**TOWN OF LOS GATOS
PLANNING COMMISSION AGENDA
AUGUST 24, 2022
110 EAST MAIN STREET
LOS GATOS, CA**

2. Consider an Appeal of the Development Review Committee Decision to Approve a Request for Construction of a New Single-Family Residence and Site Improvements Requiring a Grading Permit on Property Zoned R-1:8. **Located at 17291 Wedgewood Avenue.** APN 409-14-013. Architecture and Site Application S-21-027. PROPERTY OWNER: Young Kim. APPLICANT: Edick Lazari. APPELLANT: Douglas Scott Maynard. PROJECT PLANNER: Sean Mullin.
3. Review and Recommendation of the Draft Objective Standards to the Town Council.

DATE: August 19, 2022
TO: Planning Commission
FROM: Joel Paulson, Community Development Director
SUBJECT: Consider an Appeal of the Development Review Committee Decision to Approve a Request for Construction of a New Single-Family Residence and Site Improvements Requiring a Grading Permit on Property Zoned R-1:8. **Located at 17291 Wedgewood Avenue.** APN 409-14-013. Architecture and Site Application S-21-027. PROPERTY OWNER: Young Kim. APPLICANT: Edick Lazari. APPELLANT: Douglas Scott Maynard. PROJECT PLANNER: Sean Mullin.

Current Plan

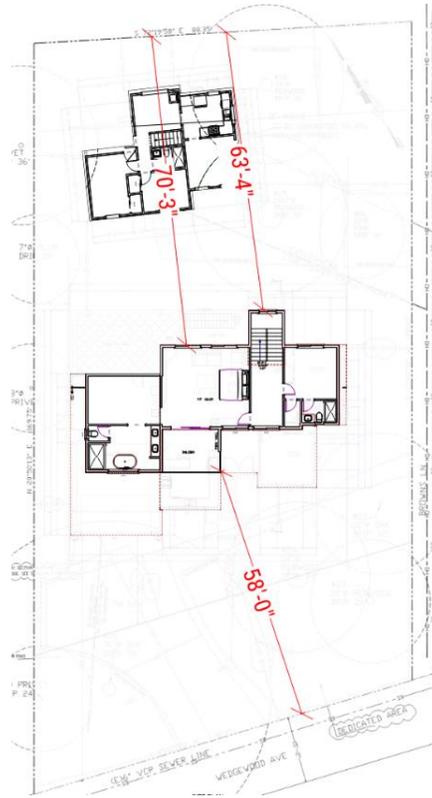
When we received feedback from the appellant and his son regarding potential impacts to their privacy, we understood the importance of addressing those concerns in our proposed plans. It should be noted however, that in a smaller lot single family residential neighborhood like ours, some visibility of one another's yards or even homes is unavoidable and an inherent part of living in a neighborhood where homes are spaced closer together. Nevertheless, we have worked diligently throughout the past 21 months to design, revise, and refine a plan for the home that not only meets

all of the applicable regulations and design guidelines, but also has minimal impact on our neighbors. To that end, we have made significant revisions to our original plan for the purpose of addressing the concerns about privacy from the appellant. More specifically, the following changes were made to the originally submitted plans in response to our neighbors' concerns regarding the proposed second floor and privacy:

D. Further, as directed by the DRC during its July 12th hearing, we will be obscuring the clerestory window of the primary bathroom and planting mature trees along the 20' of shared property line with [REDACTED].

PROPOSED LEFT SIDE ELEVATION

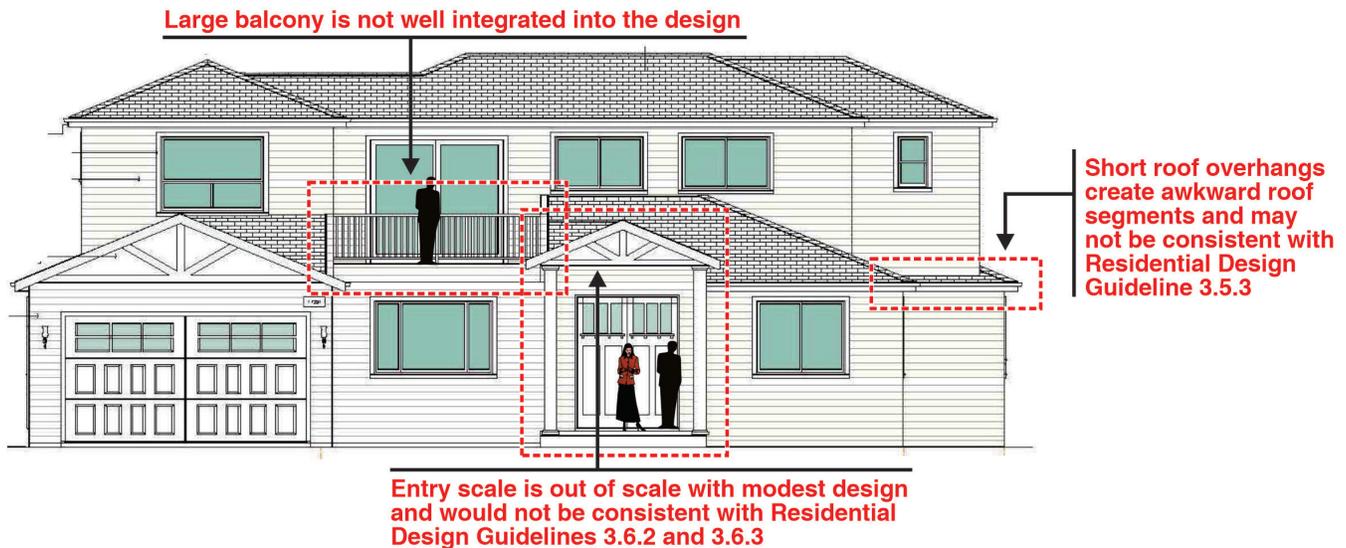
2. The very large second floor balcony is not well integrated into the overall design.
3. The roof overhangs are small for the architectural style, and result in some awkward small first floor roof segments. They may not be consistent with Residential Design Guideline 3.5.3.

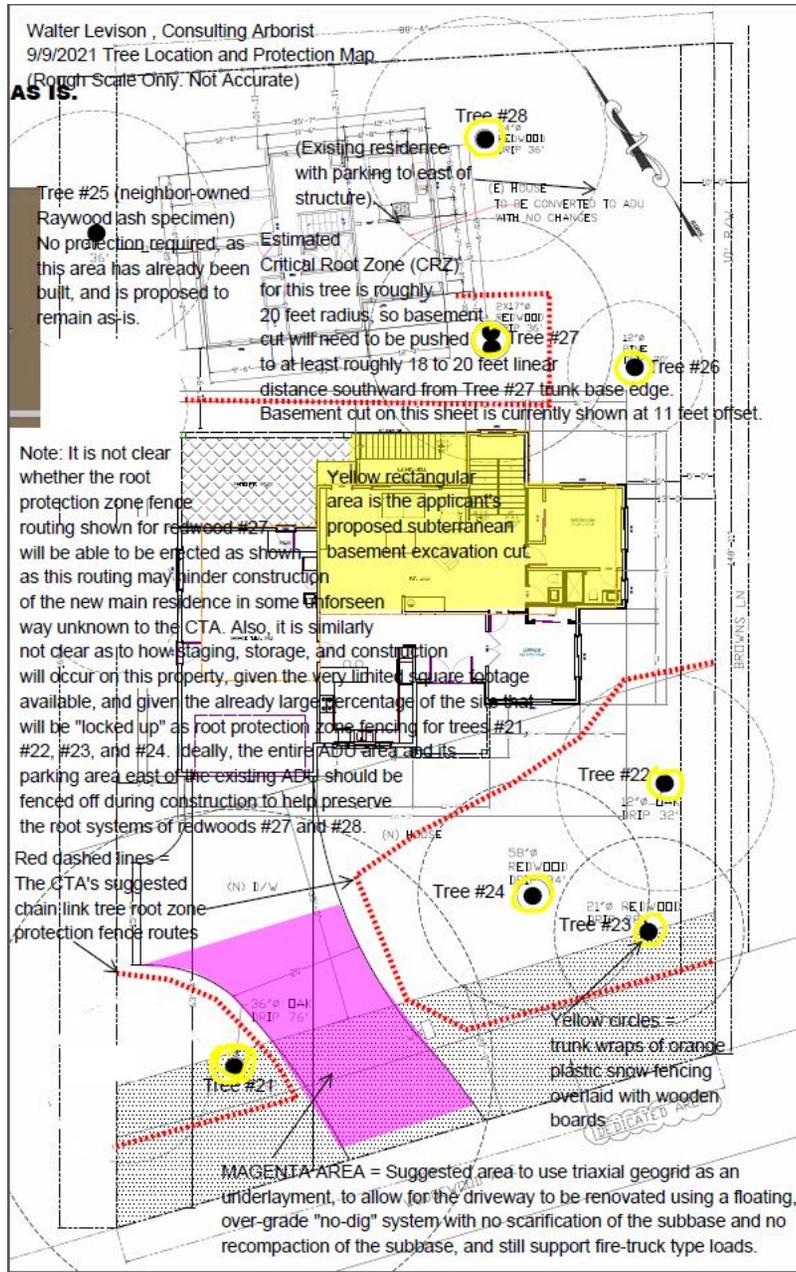
The CTA marked up the applicant's sheet A-1.0 site plan dated March, 2021 by Lazari Design of San Jose, California as the basis for the tree location map markup on the following page of this CTA arborist report.

The CTA added the following items to this plan sheet for reference purposes:

- a. Trunk plot dots are enlarged as black circles.
- b. (Tree canopies were already indicated by the architect, and are somewhat accurate in terms of true scale radius and diameter).

Figure A.3.1

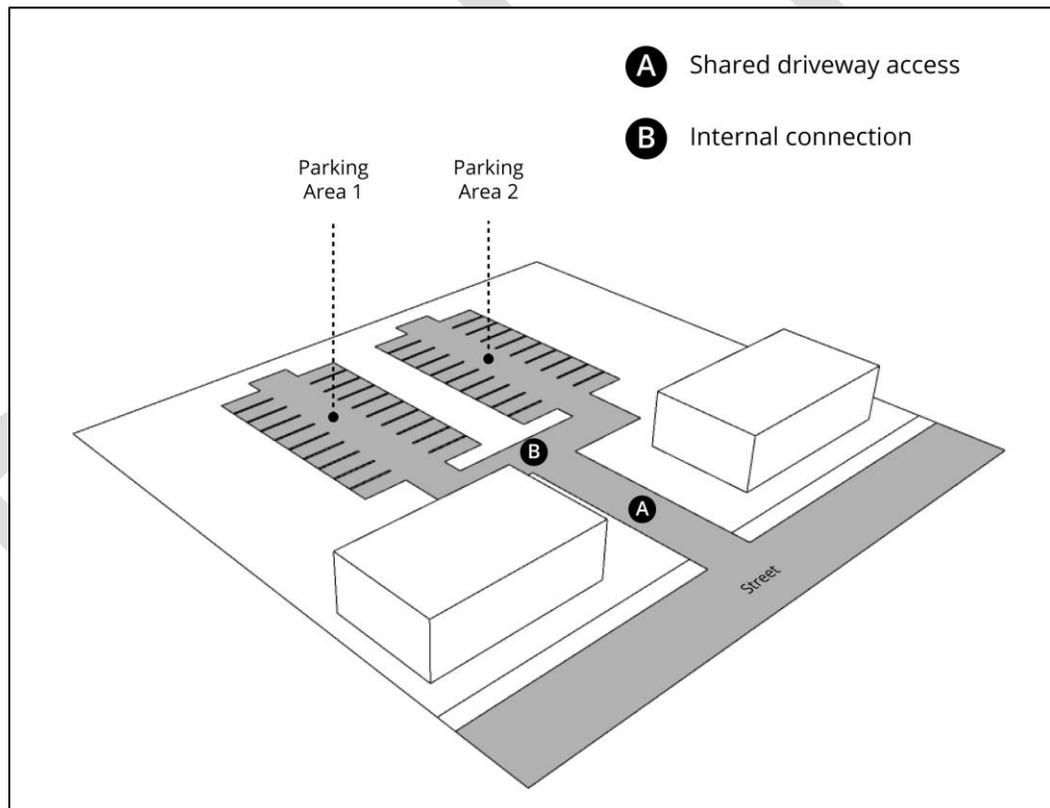
Figure A.3.1, A.3.1 and A4.3 need clarification

:What is the difference between aisle to aisle circulation (A3.1) and parking areas (Figure A3.1)? Does Figure A.3.1 represent multiple parking areas (see A.4.2) or aisle-to-aisle circulation of A.3.1.

Figure A.11.1

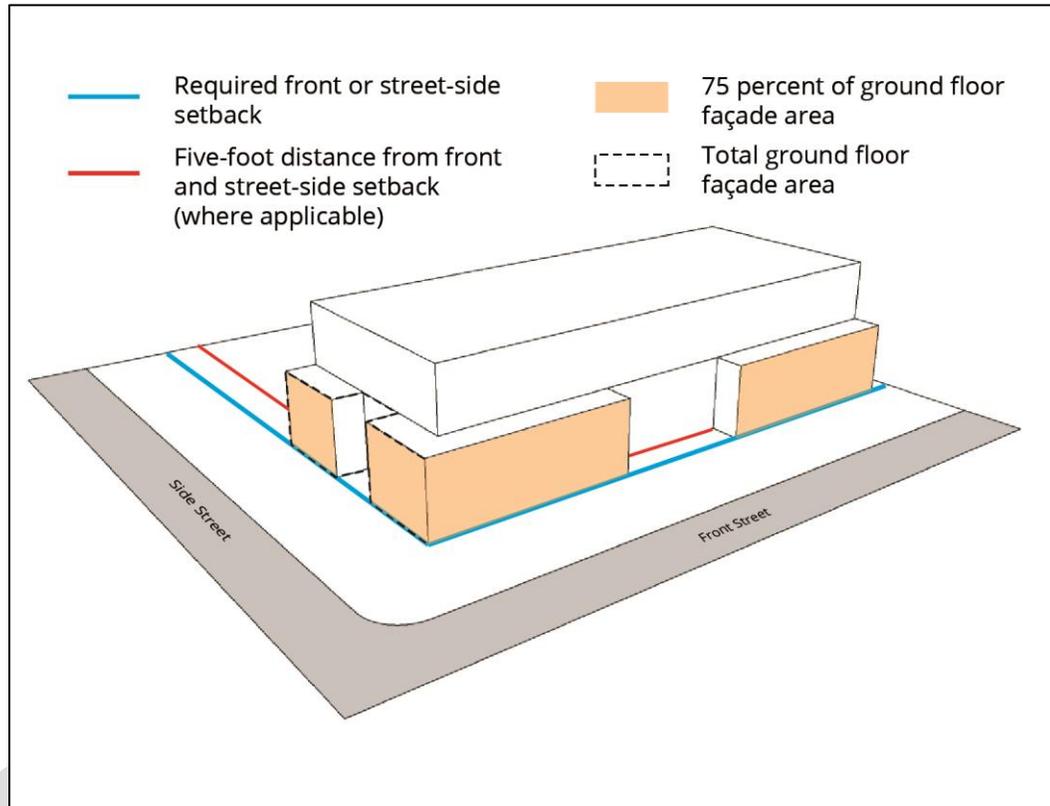
41	A.10.1	A.11.1	Why does this only include Community Growth Districts (CGDs)?	<p>The following polices discussing setbacks are included in the Community Design Element of the 2040 General Plan:</p> <p>CD-2.10 (Town-wide): Well-Defined Street Fronts - Require new buildings to maintain a consistent setback from the public right-of-way in order to create a well-defined streetscape. Require new buildings throughout Town to use consistent setbacks.</p> <p>CD-7.1 (All CGDs): Neighborhood-Friendly Design - Encourage buildings and sites within all Community Growth Districts regardless of designation, including shopping centers undergoing redevelopment, to integrate design features that create a pedestrian- and neighborhood-friendly environment, such as by siting buildings close to the sidewalks, providing space for small plazas, and including public art.</p> <p>CD-9.1: (LGB CGD): Setbacks and Step Backs of Massing - Require medium density, high density, and mixed-use parcels in the Los Gatos Boulevard District adjacent to single-family parcels to include increased site setbacks and multi-story step backs to minimize the impact and increase compatibility with smaller adjacent structures.</p> <p>CDP-11.7: (Lark CGD): Reduced Setbacks - Allow reduced setbacks to foster a more urban environment focused on corporate centers, commercial shopping areas, medical services, and hospitality uses.</p> <p>Consistent setbacks are encouraged by CD-2.10, while reduced setbacks are encouraged in CGDs. For this reason, Standard A.11.1 was written specific to CGDs. Given the above polices and the comments made by the Commission during discussion of this item, staff requests direction on whether this standard should apply Town-wide or only within CGDs. The corresponding figure/diagram will be updated accordingly.</p>
